Re: St. Lucie Unit 2
Docket No. 50-389
Order (EA-03-009) Interim RPVH Inspection Requirements
Revised Relaxation Requests 1 and 2 - Supplement 4

ST. LUCIE UNIT 2 RELAXATION REQUEST NO. 1 REVISION 2 FROM US NRC ORDER EA-03-009

ST. LUCIE UNIT 2 RELAXATION REQUEST NO. 2 REVISION 1 FROM US NRC ORDER EA-03-009

FRAMATOME ANP
Weld Profile
Penetration #18
Circumferential Position (Degrees)
Axial Position From Bottom of Penetration (Inches)
10.0
9.5
9.0
8.5
8.0
7.5
7.0
6.5
6.0
5.5
5.0
4.5
4.0
3.5
3.0
2.5
2.0
1.5
1.0
0.5
0.0
0
30
60
90
120
150
180
210
240
270
300
330
360
1
2
3
4
5
6
7
Noz./Funnel Gap

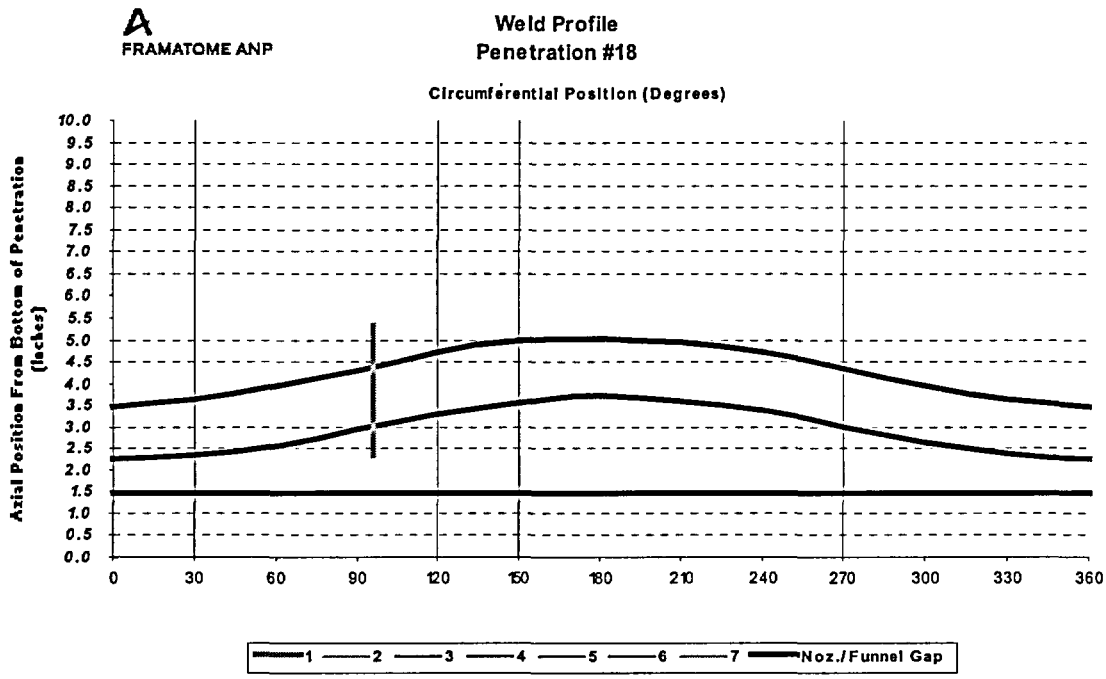
NRC Question 3: Provide the location of the flaw for Penetration Nos.18 and 72 relative to the weld and azimuthal angle around the nozzle.

FPL Response to Question 3: A single flaw was identified in Nozzle Nos. 18 and 72 at St. Lucie Unit 2. The details of each are provided in the table below. A graphical weld profile and flaw orientation is also provided. The 0° is identified as lowest downhill position of the weld.

Nozzle #	Flaw Location /Type	Azimuthal Location	Flaw Length	Flaw Depth	Distance Below Weld
18	OD Axial	96°	2.98"	0.26"	0.71"
72	OD Axial	354°	0.96"	0.28"	0.35"
